UNITED STATES PATENT AND TRADEMARK OFFICE

10/608,671

Office Action Summary

DETAILED ACTION

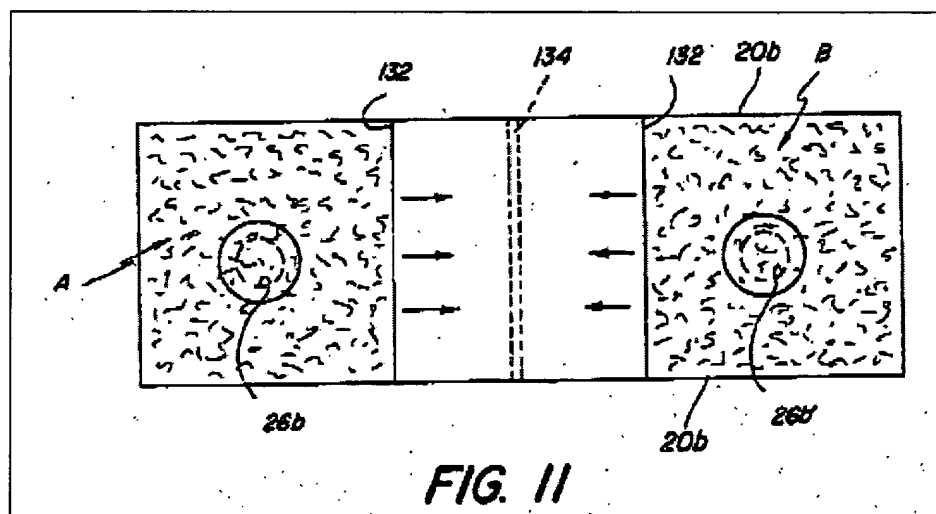
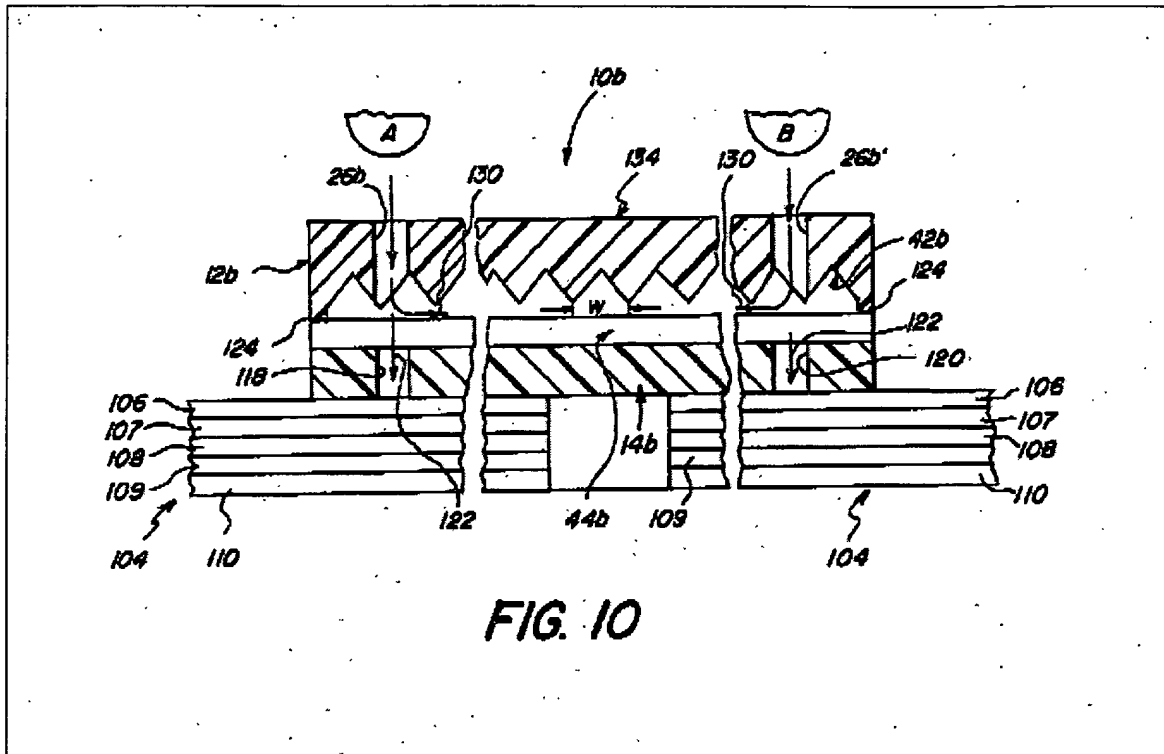
Regarding claims 1 and 2, Columbus '029 teaches a microfluidic apparatus (10) comprising: an inlet port (aperture 26); a capillary passageway (e.g., the sidewalls of the inlet port 26 extending through top member 12) in fluid communication with the inlet port (26); an inlet chamber (e.g., the spacing between interior surfaces 16 & 18) in fluid communication with the capillary passageway, wherein the inlet chamber comprises means (grooves 42 & 44) for uniformly distributing sample fluid across the chamber and displacing air from the chamber; and at least one vent passageway (e.g., the space between members 12 & 14 left exposed at either edge 20 or 22) or additional aperture (e.g., 26b') (see col. 1, line 1 – col. 6, line 60; figures 1 – 3).

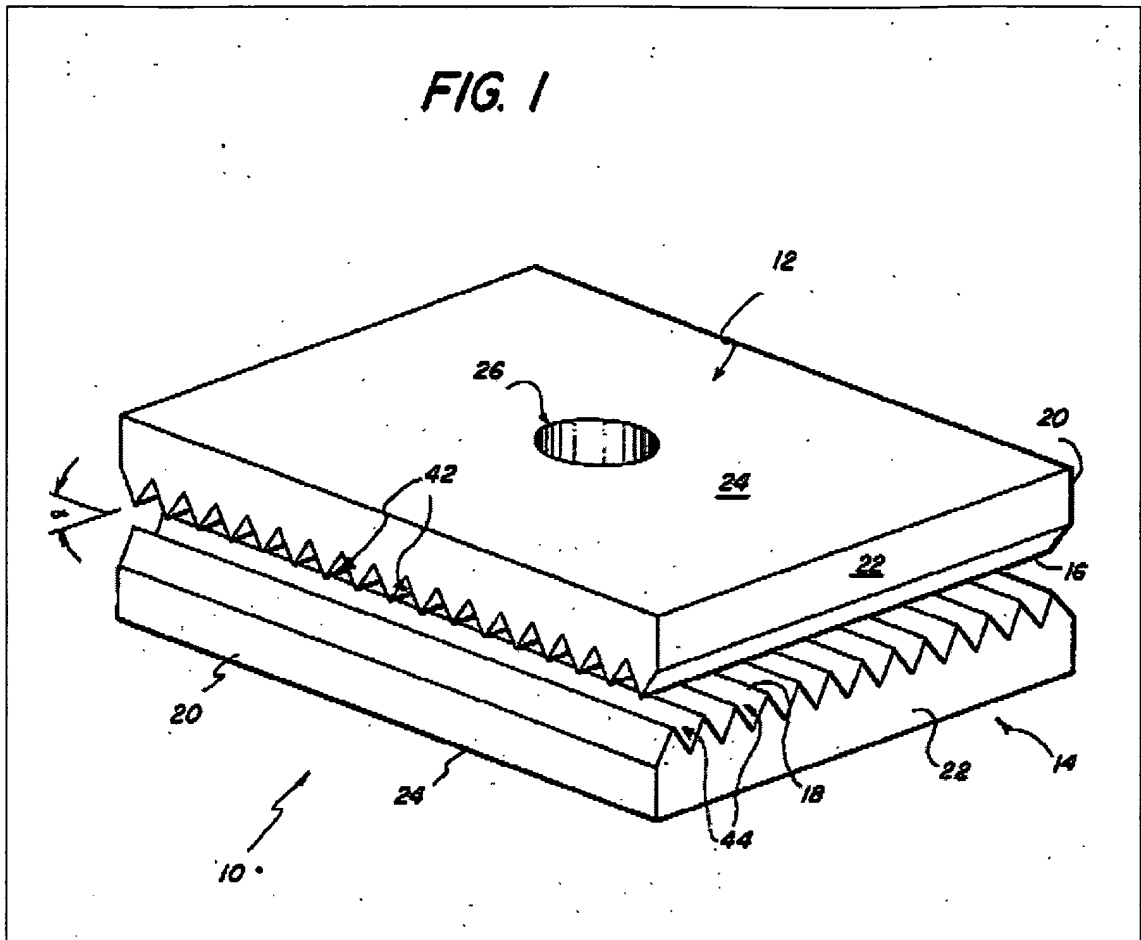
As shown in figures 10 and 11, Columbus '029 further anticipates the incorporation of an enclosed inlet chamber (apertures 26b or 26b') at one side thereof the device.

As shown in figure 10, Columbus '029 anticipates an enclosed passageway. Walls 124 & 144 enclose passageway defined by 44b (see col. 11, lines 1 – 16; fig. 10). Columbus '029

teaches that walls 124 can be additional closure walls, thereby forming an enclosed structure (see col. 12, lines 47 – 57).

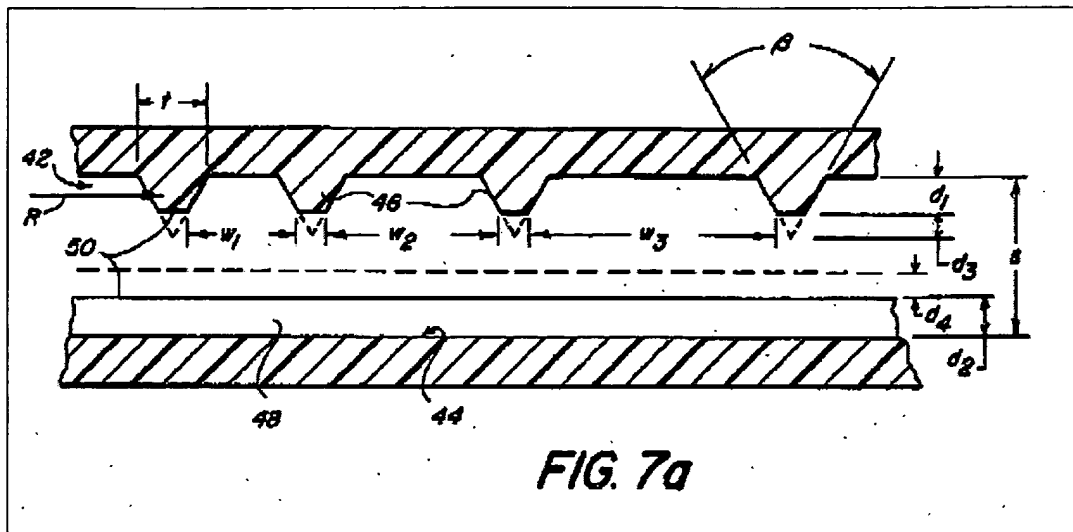
Regarding claim 3, as shown in figure 7a, Columbus '029 further teaches the incorporation of weir structures (truncated ridges 46) within the apparatus (see col. 8, lines 1 – 51).

FIG. 1

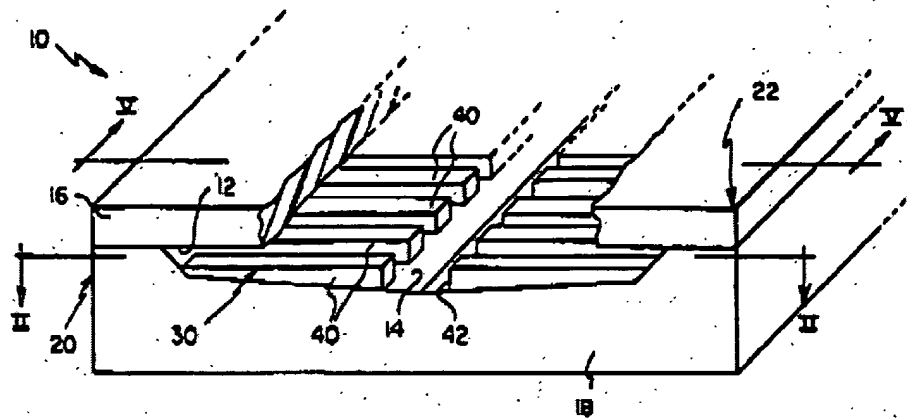
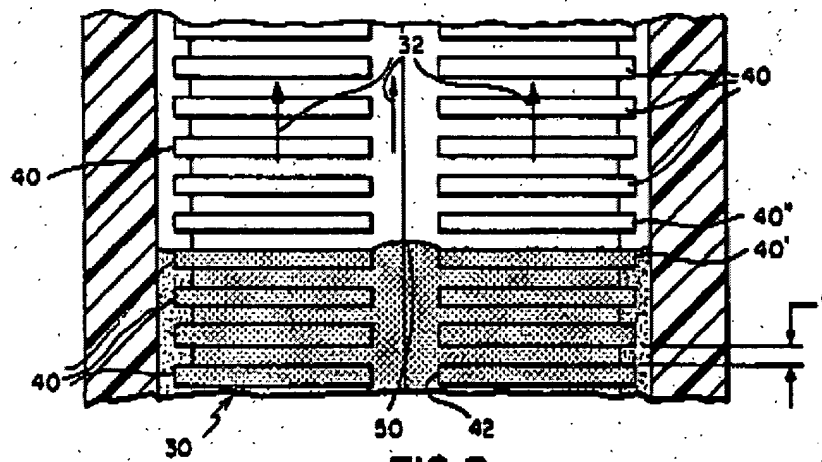
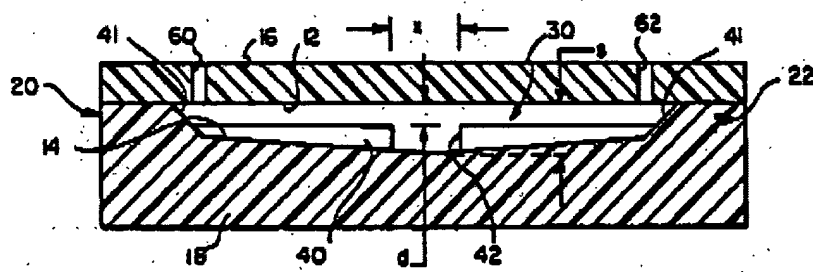
Regarding claim 2, Columbus '476 teach the incorporation of groove or slot structures (142g') within the apparatus. Columbus '476 anticipates an enclosed passageway (e.g., enclosed

transport zone 30) via the placement of cover top member 16 and bottom member 18 (see col. 3, lines 25 – 50; figures 1, 2 & 5).

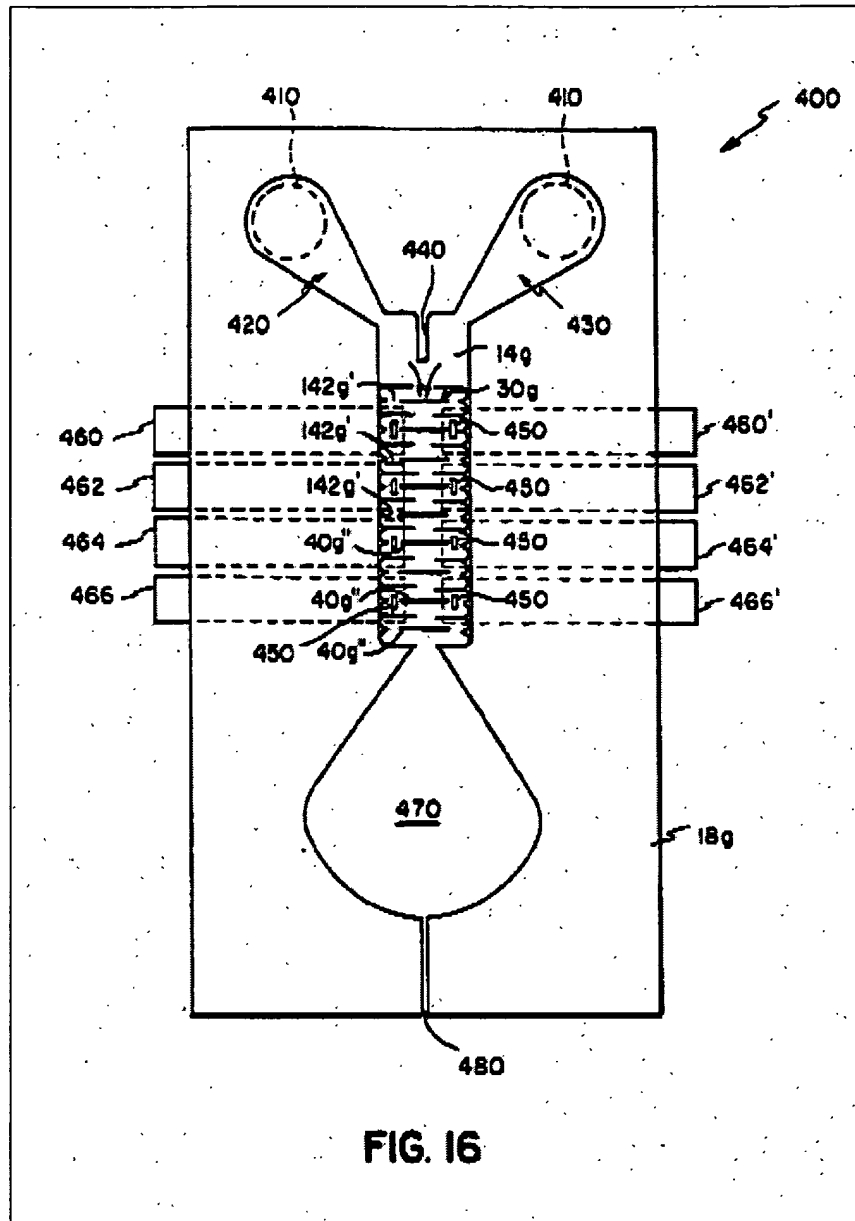
Regarding claims 1 and 3, as shown in figure 16, Columbus '476 teaches a microfluidic apparatus (multiple test element 400) comprising: an inlet port (inlet aperture 410); a capillary passageway (liquid delivery capillary zones 420 & 430) in fluid communication with the inlet port (410); an inlet chamber (capillary transport zone 30g) in fluid communication with the capillary passageway (420 & 430), wherein the inlet chamber comprises means (e.g., rib structures 40g", which are structurally equivalent to a weir structure) for uniformly distributing sample fluid across the chamber and displacing air from the chamber; and at least one vent passageway (e.g., vent aperture 480) at a side opposite the entry of the capillary passageway (see col. 7, lines 15 – 64; figure 16).

Regarding claim 9, Columbus '476 teaches the incorporation of an overflow cavity or chamber (470) within the apparatus.

Fig. 3b

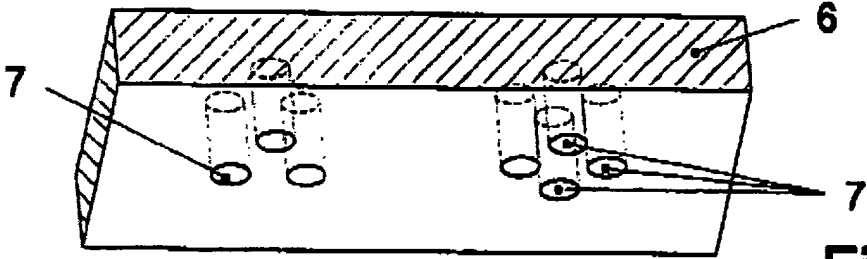
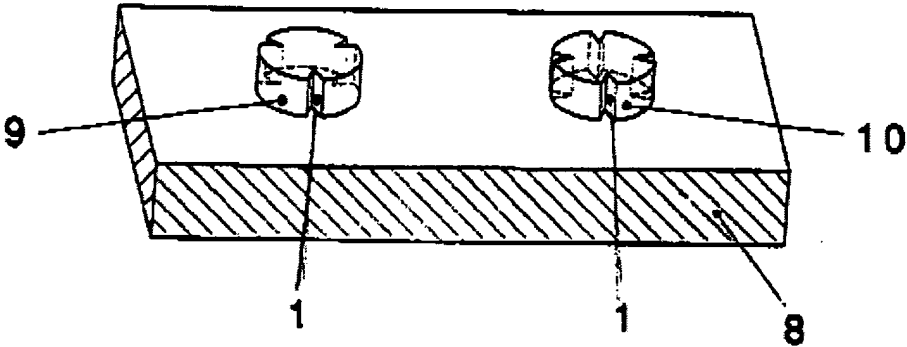
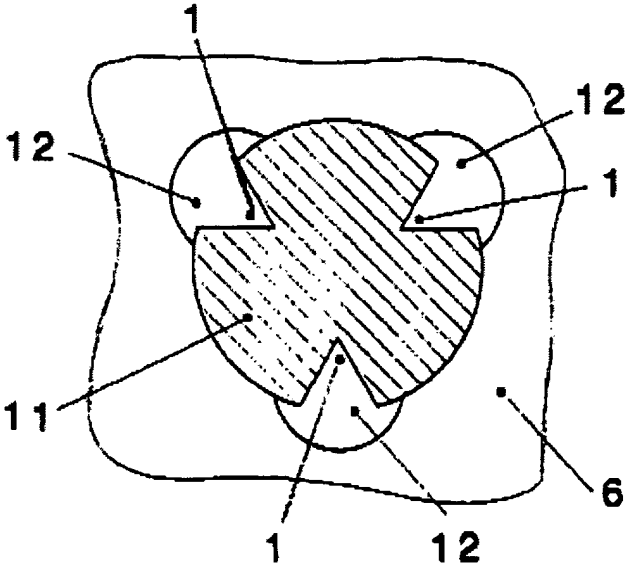
1. Claims 4 – 6 are rejected under 35 U.S.C. 103(a) as being unpatentable over Columbus '029 in view of Peters (U.S. Pat. No. 6,296,126 B1). Regarding claim 4, Columbus '029 is silent to the specific teaching of incorporating wedge-shaped cut-out structures with the microfluidic apparatus. As shown in figure 3b, Peters does teach the incorporation of wedge-shaped cut-out structures (columnar projection 9 having wedge-shaped cut-outs 1) within a microfluidic apparatus for facilitating effective fluid control within a microfluidic device (see col. 1, line 10 – col. 6, line 67; figures 1a, 3b & 4).

Regarding claims 5 and 6, as shown in figure 3b, these cylindrical or columnar projections (9) comprise essentially post structures, which extend from the base-plate (8), having wedge-shaped cut-outs (1) (see col. 5, lines 1 – 15).

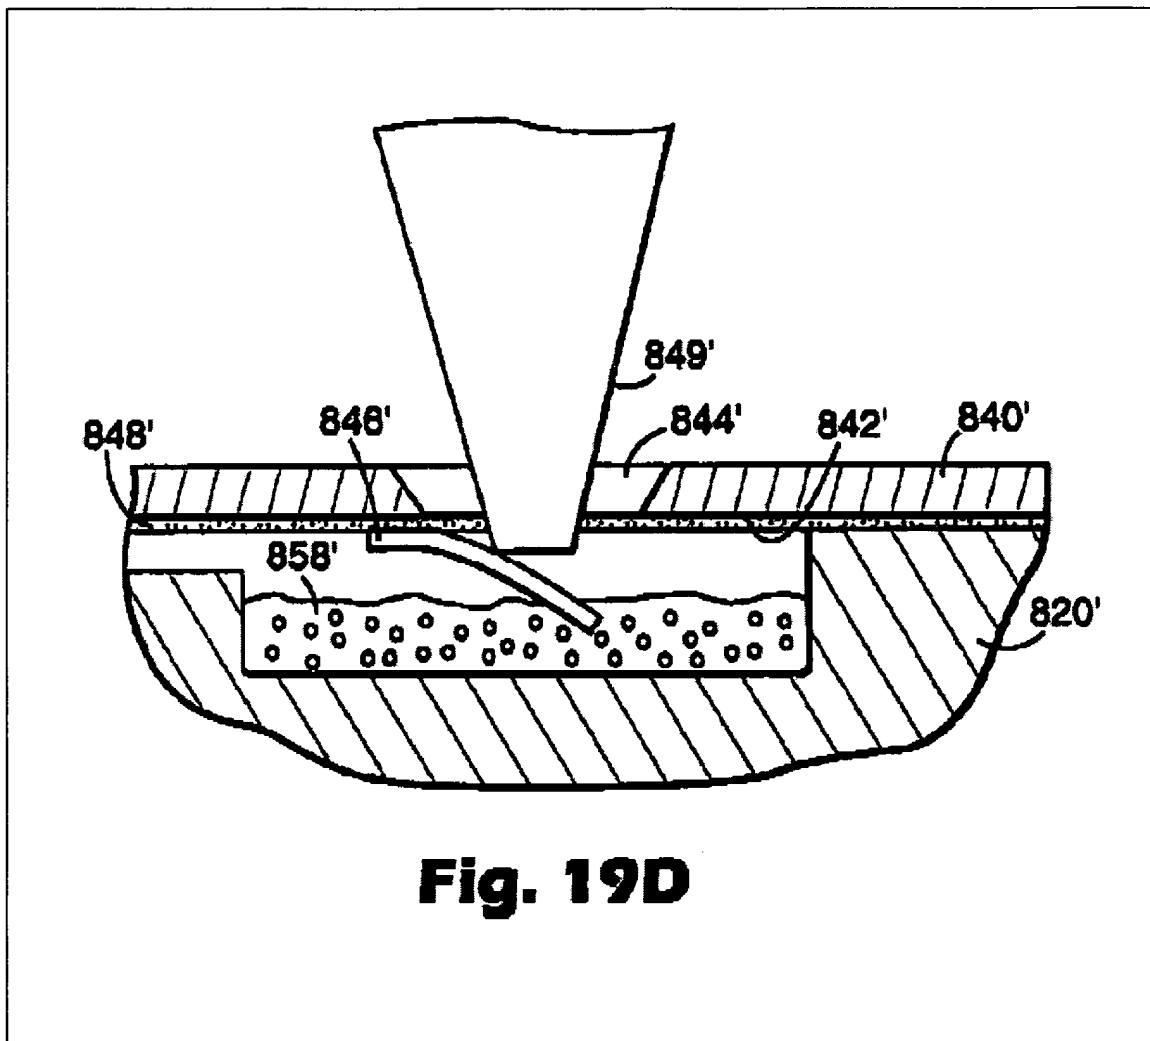
2. Claim 7 is rejected under 35 U.S.C. 103(a) as being unpatentable over Columbus '029 in view of Bedingham et al. (U.S. Pat. No. 6,734,401 B2). Columbus '029 is silent to the specific teaching of incorporating an inlet port that is tapered to engage the corresponding shape of a pipette tip for depositing a sample fluid into the apparatus. Bedingham et al. do teach the incorporation of an inlet port (844') that is tapered to facilitate engagement with the corresponding shape of a pipette probe tip (849') for permitting the introduction of a sample fluid into the disclosed apparatus (see col. 32, lines 19 – 61; figure 19D).
